**Comments of the U.S. Department of Energy and Washington TRU Solutions, LLC,
Regarding the NMED's Intent to Approve a Class 3 Permit Modification Request
Pursuant to Public Notice 05-16**

On November 23, 2005, the New Mexico Environment Department (NMED) issued Public Notice No. 05-16 stating that it intends to approve a Class 3 modification to the Hazardous Waste Facility Permit (HWFP) for the Waste Isolation Pilot Plant (WIPP), EPA ID No. NM4890139088. NMED also issued a Fact Sheet setting out the basis for the draft Permit. The Permittees generally support the draft Permit, and with these comments, propose alternative text. Text to be included in the draft Permit not only promotes safe, efficient operations at waste generator/storage sites and at the WIPP, but also increases NMED oversight.

Figure 1 – Flowchart of Procedural Steps for Return of Prohibited Items

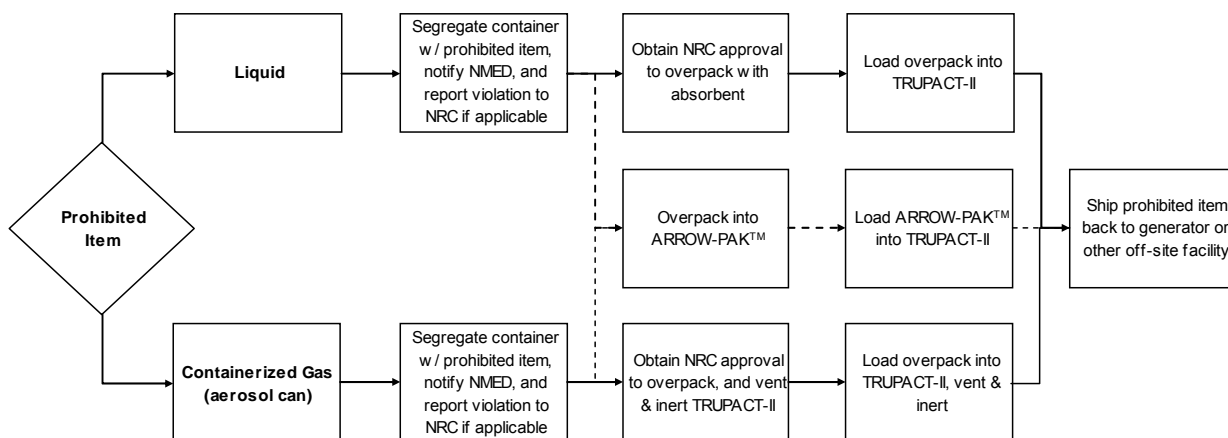
In the attached Comment matrix, the Permittees propose permit text to HWFP Attachment B7 that sets forth the procedural steps the Permittees will follow if a prohibited item were to be identified during confirmation activities at the WIPP. Figure 1, *Flowchart of Procedural Steps for Return of Prohibited Items*, is shown below.

Figure B4-2
Acceptable Knowledge Auditing

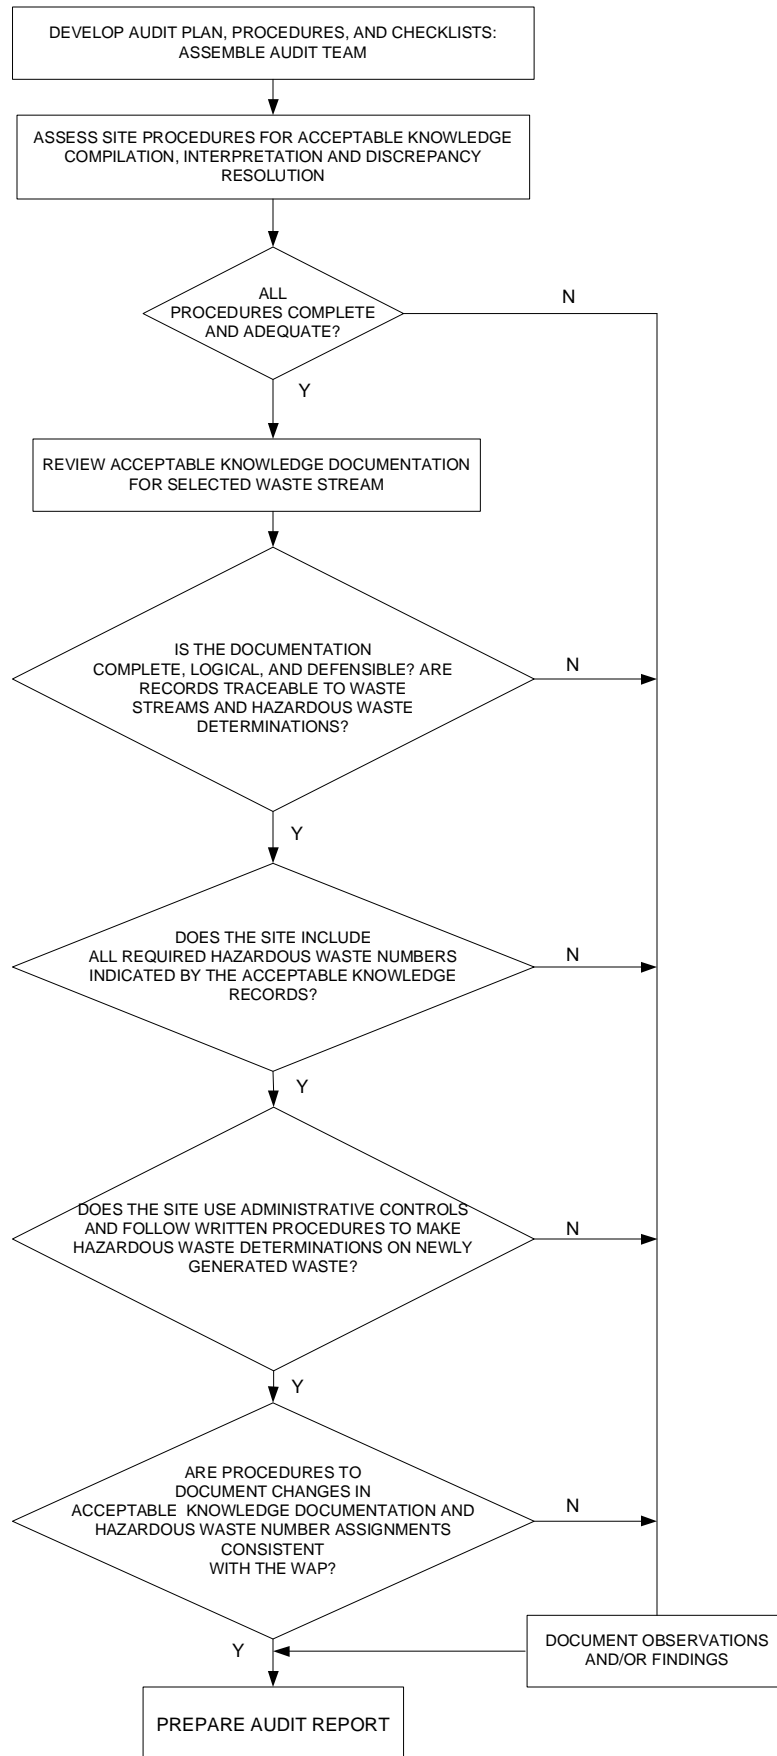
Figure B4-2	B4-25		Deleted 8 th item.	Revised figure is attached.
INTRO.	B7-1	6-15	Reinserted the ability to perform confirmation at WIPP.	The Permittees demonstrate compliance with the Permit by ensuring that the waste characterization processes performed by generator/storage sites (sites) produce data compliant with the

Figure B7-1
TRU Mixed Waste Screening Flow Diagram

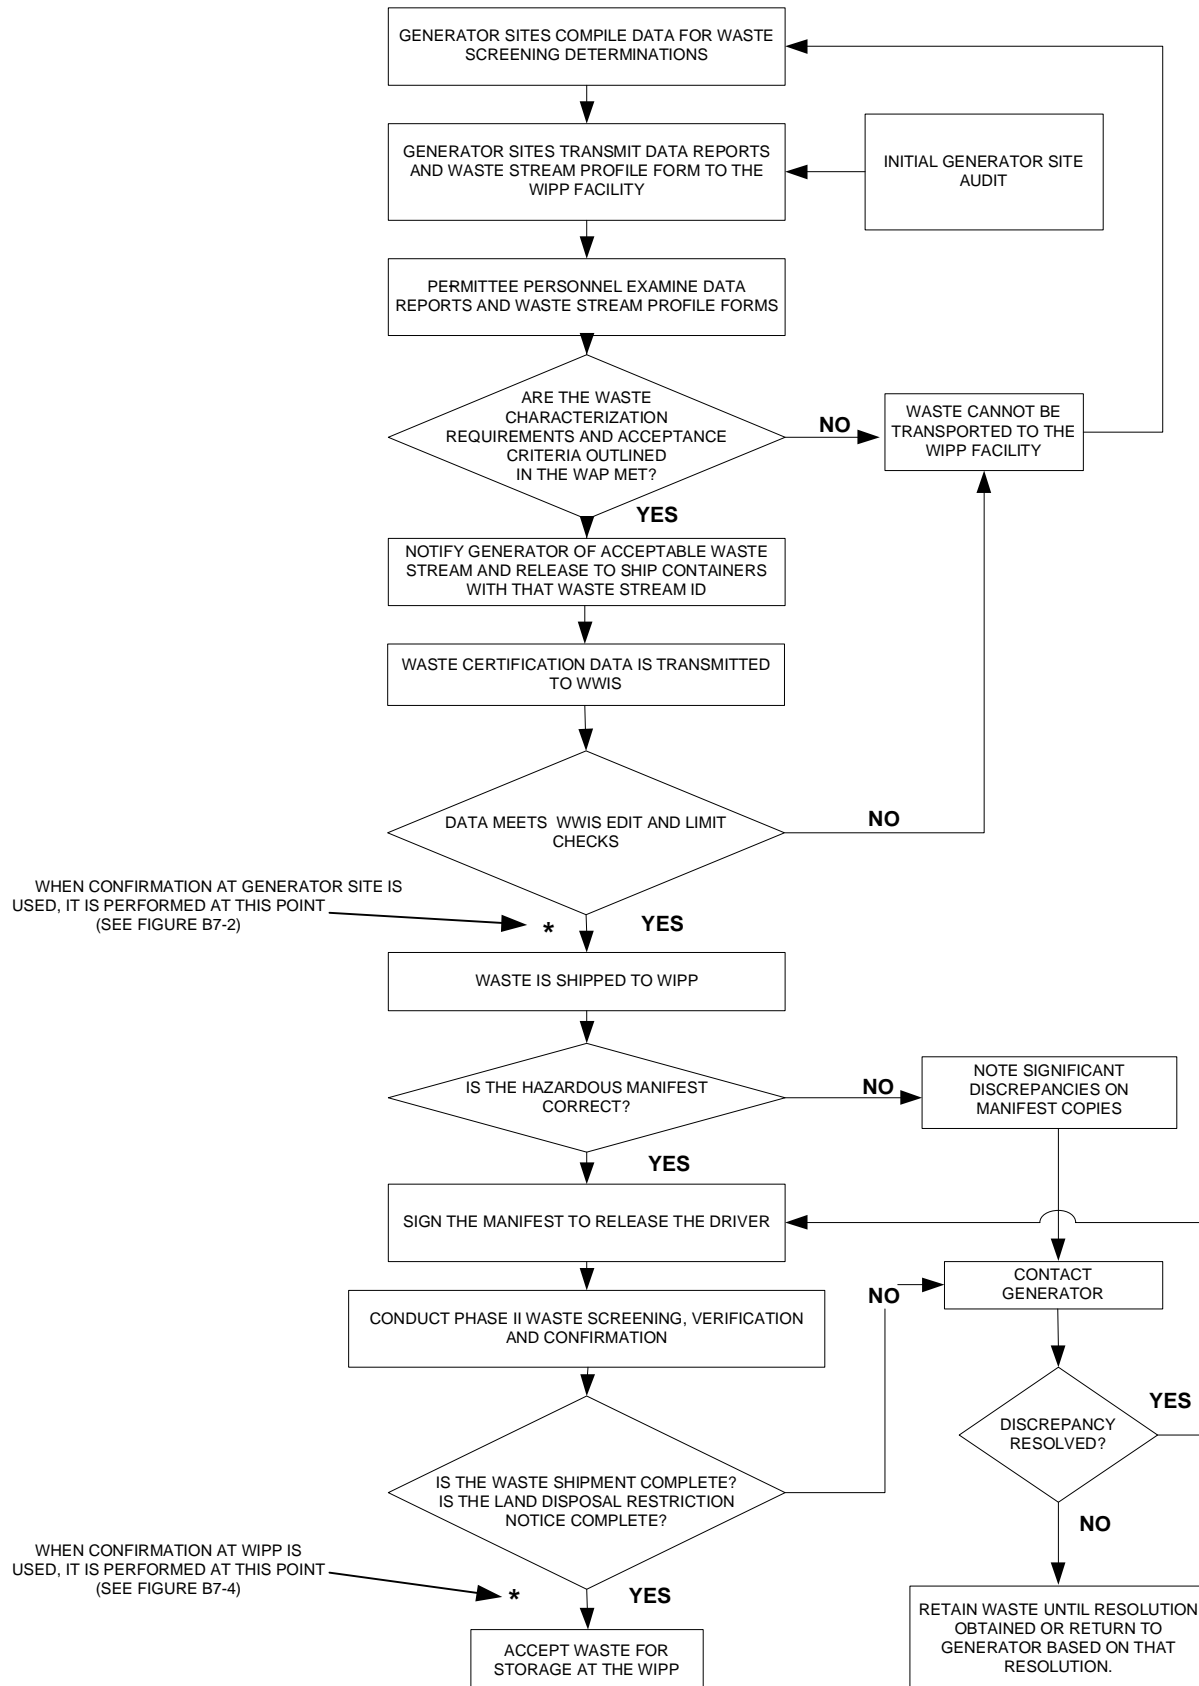
Figure B7-1	B7-29		Reinserted Permittees' Figure B7-1 in lieu of NMED version of Figure B7-1 with changes.	Figure B7-1 is attached.
Figure B7-2	B7-30		Revised 3 rd and 4 th blocks, top row of figure B7-2 to read "Perform Radiography, Review of Radiography	Revised figure is attached.

Figure B7-2
Waste Confirmation at an Offsite Facility

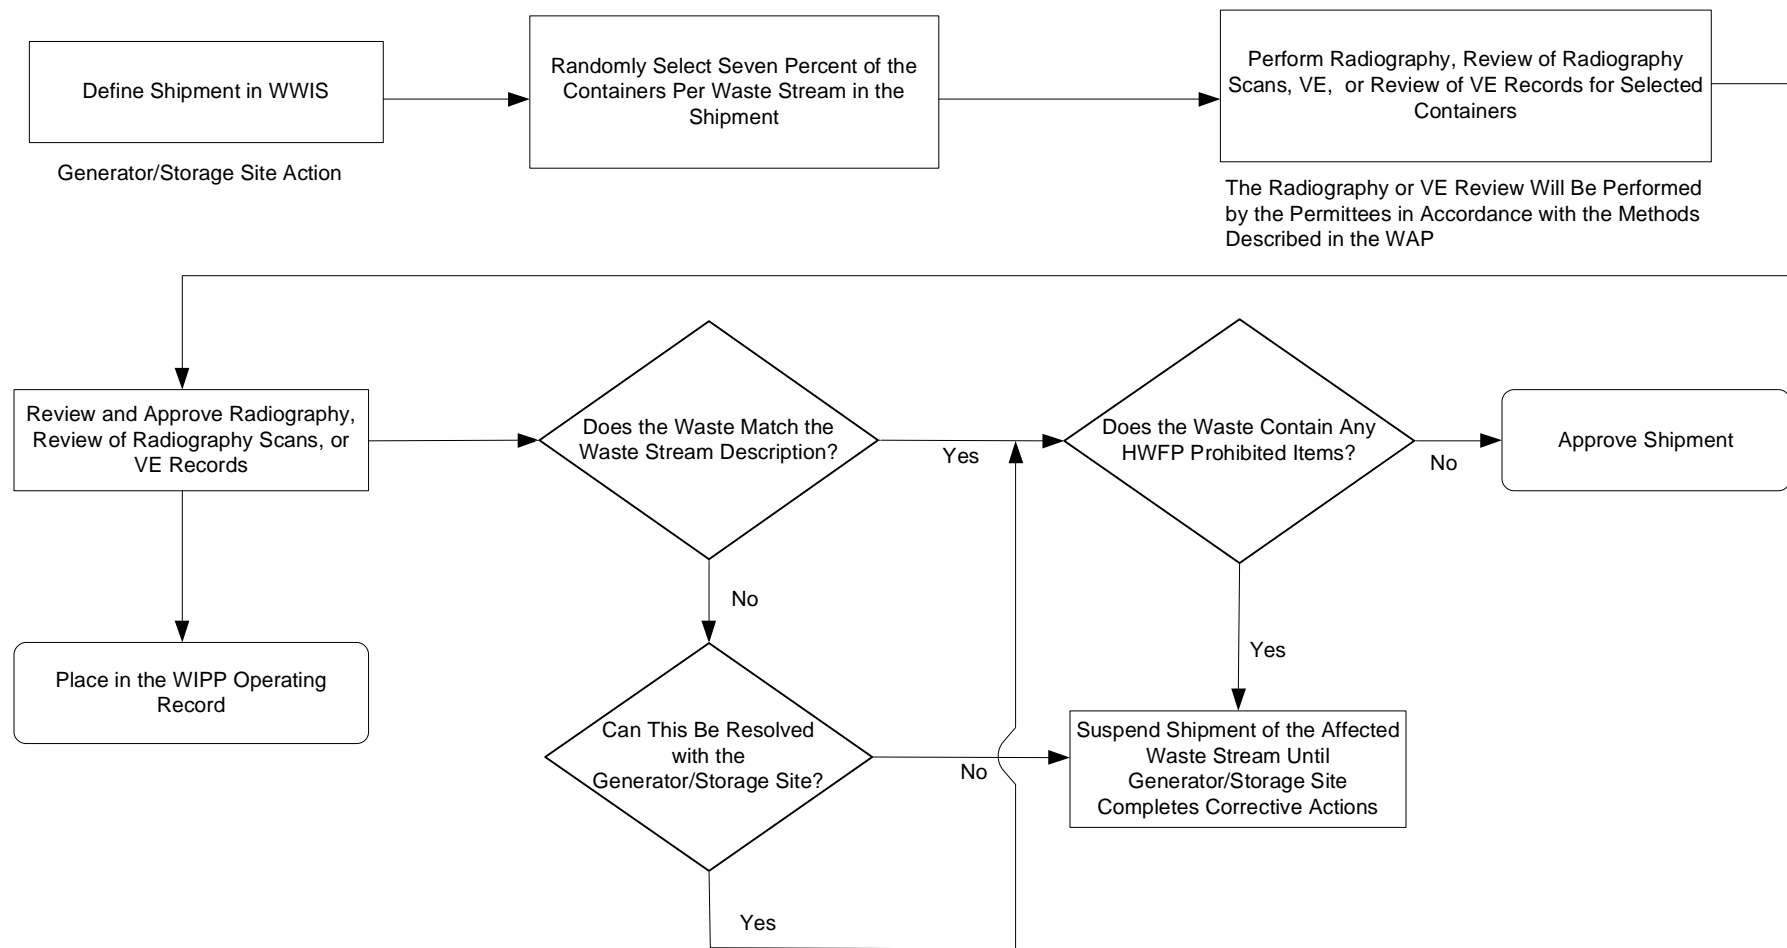
Att/Module and Section	Page	Line	Comment	Proposed Change to Draft Permit
			Scans, VE, or Review of VE Records for Selected Containers.”	
Figure B7-3	B7-31		Reinserted Figure B7-3 with changes.	Figure B7-3 is attached.
Figure B7-5			Reinserted Figure B7-5 and identify as Figure B7-4 with changes.	Figure B7-4 is attached.
C-1a(2)	C-2 – C-3	31-41, 1-9	Revised entry control to include holding areas.	<p>For the purposes of entry control to areas where wastes are being handled, the Waste Handling Building Container Storage Unit (WHB Unit), the boundaries of the Parking Area Unit south of the WHB, <u>the holding areas</u> and those portions of the underground where wastes are disposed are posted as Controlled Areas (CAs). The WIPP allows access to a CA by anyone who has successfully completed General Employee Radiological Training, which is included in the General Employee Training Course. Access for visitors can also be arranged with proper training.</p> <p>Areas within the CA, however, may have further access restricted. Smaller areas may be designated as Radiological Buffer Areas, Radiation Areas, and Radioactive Materials Area. These smaller areas are generally within the direct vicinity of waste handling activities, <u>waste confirmation activities</u>, or waste storage or disposal areas. They are sized and posted in accordance with strict guidelines. Activities in these areas are performed under a Radiological Work Permit (RWP), and personnel must be listed on the RWP before they are allowed to enter. To be listed on the RWP, personnel must have the appropriate radiological and hazardous waste worker training and must have available radiation dose for the task. In addition, the individuals must sign the RWP acknowledging that they intend to comply with the radiological controls that are in place. Personnel may be escorted into the smaller areas if they are escorted by a person who meets all of the above requirements and is not performing any work in the area.</p> <p>The WHB Unit, the Parking Area Unit, <u>the holding areas</u>, and the underground Hazardous Waste Disposal Units (HWDUs) will be posted with a sign that states: "Danger: Authorized Personnel Only" in both English and Spanish.</p>

Figure G-3
Typical Waste Transport Routes in Waste Handling Building - Container Storage Unit

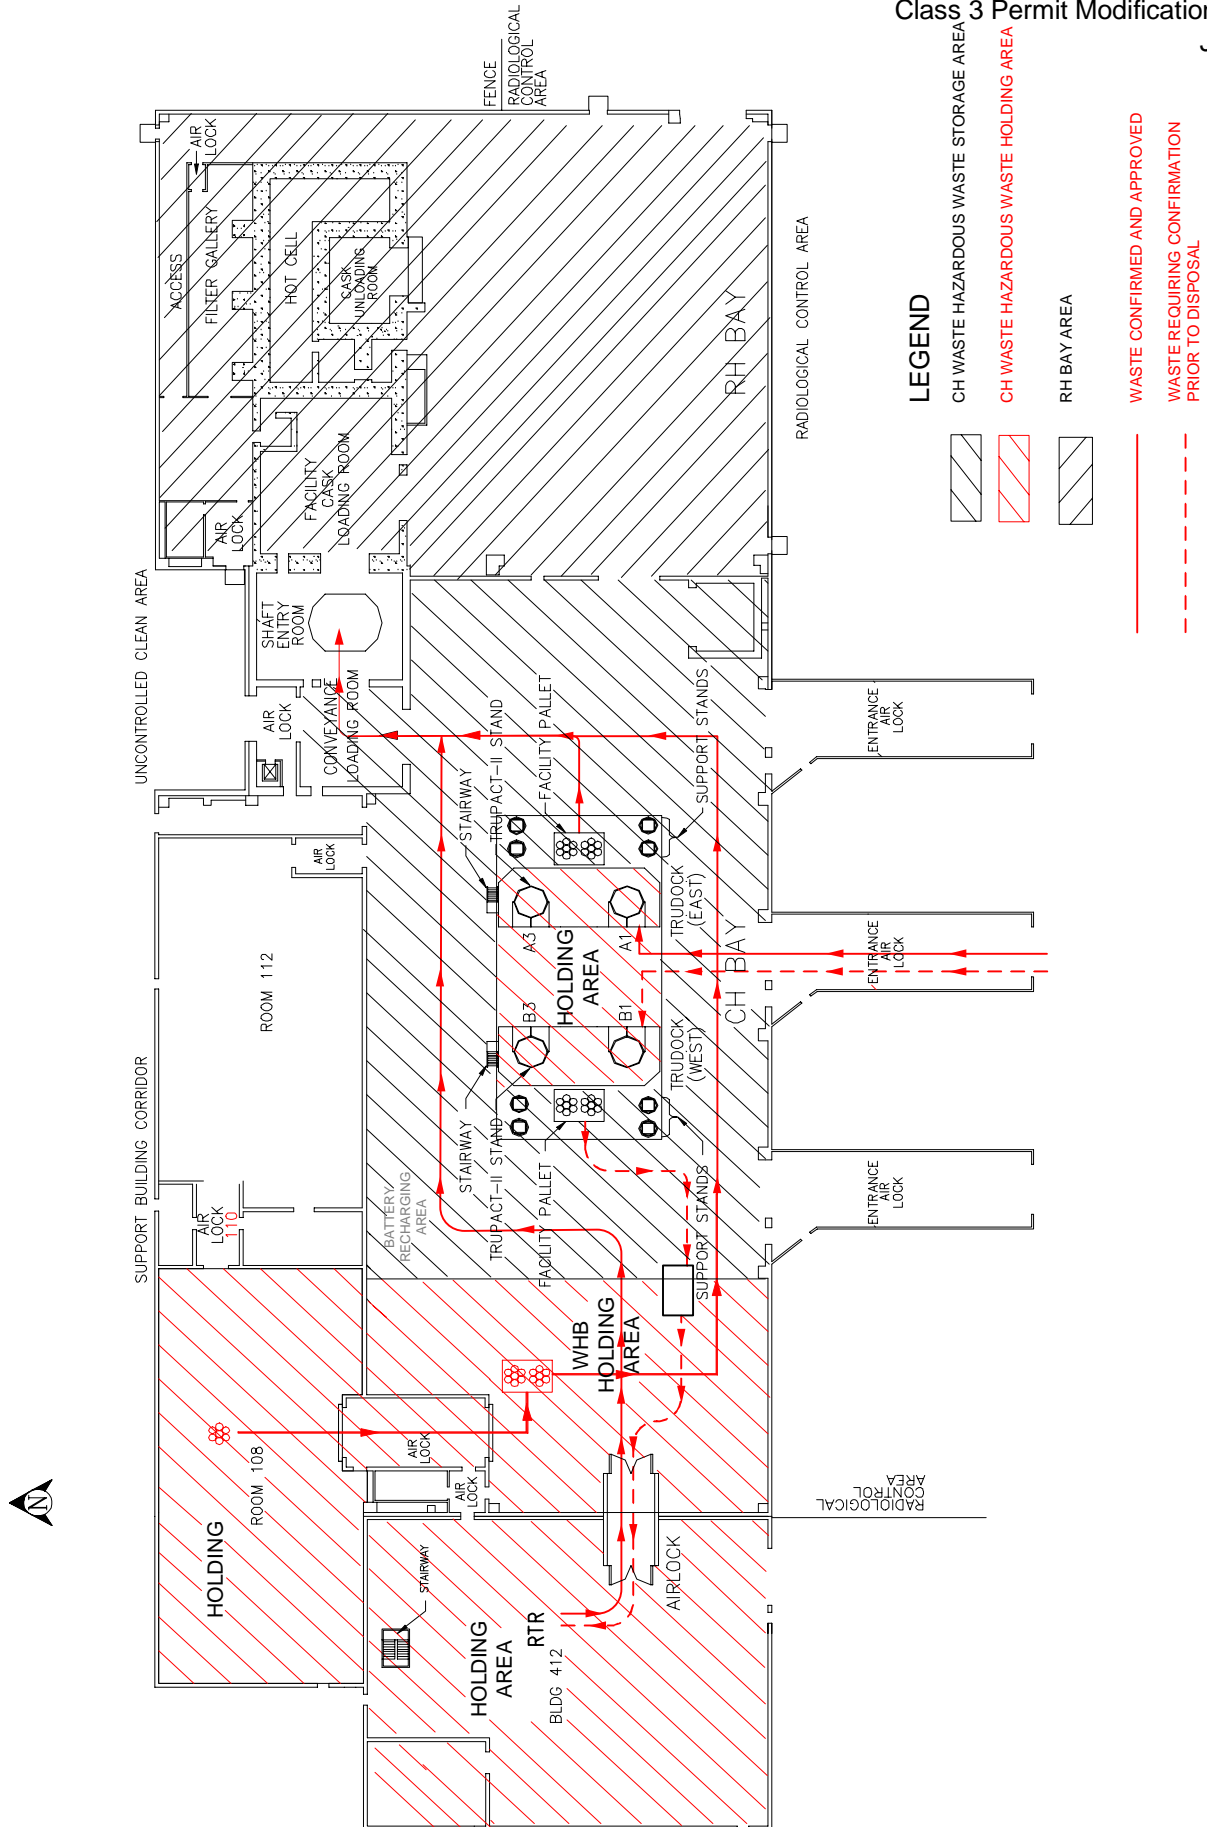
Figure G-3	G-15		Reinserted Figure G-3 to show waste movement during the confirmation process.	Figure G-3 is attached.
H1	H1-38	15-17	The Permittees believe that this additional education requirement is unnecessary. The most appropriate background for a Visual Examination Expert (VEE) is previous experience in the generation and packaging of TRU mixed waste. These personnel may not have any college level education. The added educational requirement may eliminate well qualified individuals from being selected as VEEs. The Permittees request that the requirement for two years of college-level education be deleted.	Requisite Skills, Experience and Education: Academic or vocational high school diploma or equivalent, plus two years of college-level technical study with courses in nuclear waste management and health physics, or equivalent.
I - Introduction	I-1	2-25	Revised to include holding areas that must undergo closure.	This Permit Attachment contains the Closure Plan that describes the activities necessary to close the Waste Isolation Pilot Plant (WIPP) individual units and facility. Since the current plans for operations extend over several decades, the Permittees will periodically reapply for an operating permit in accordance with Title 20 of the New Mexico Administrative Code, Chapter 4, Part 1 (20.4.1 NMAC), Subpart 900 (incorporating 40 CFR §270.10(h)). Consequently, this Closure Plan describes several types of
